From: Alex Klose
Sent: Friday, December 9, 2022 10:10 AM
To: Jennifer Lindo
Subject: FW: 230 Flanders Road
Attachments: 2002 Connecticut Guidelines for Soil Erosion and Sediment Control - Level Spreaders.pdf; 230 Flanders Road - East Lyme CT - Grading & Drainage Plan (2022-12-05).pdf; 230 Flanders Road - Pond Report.pdf

I reviewed the Wetlands/Zoning application for 230 Flanders Road "Soapy Noble". I asked the applicant's engineer to send me the revised calculation's attached (Jenn please add to the record along with this email) to confirm a couple of questions I had. These will be integrated into the final stormwater report pending either of your comments and/or the commissions' comments.

Subject: 230 Flanders Road

Figure LS-1 Minimum Dimensions for Level Spreader

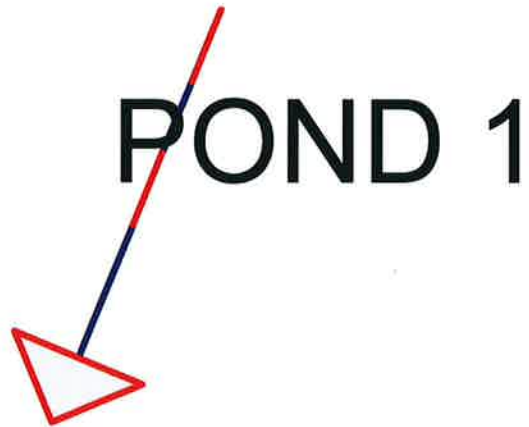
- Revised pond report correcting the culvert from a 12" to a 24" pipe
- Revised grading plan showing correct level spreader dimensions
 - We had previously shown an oversized 20' x 6' level spreader, which has been corrected to 10' x 6'
- Section from the CT SEC guidelines showing that for 0-10 cfs flows, a 10' x 6' x 0.5 deep level spreader is adequately sized
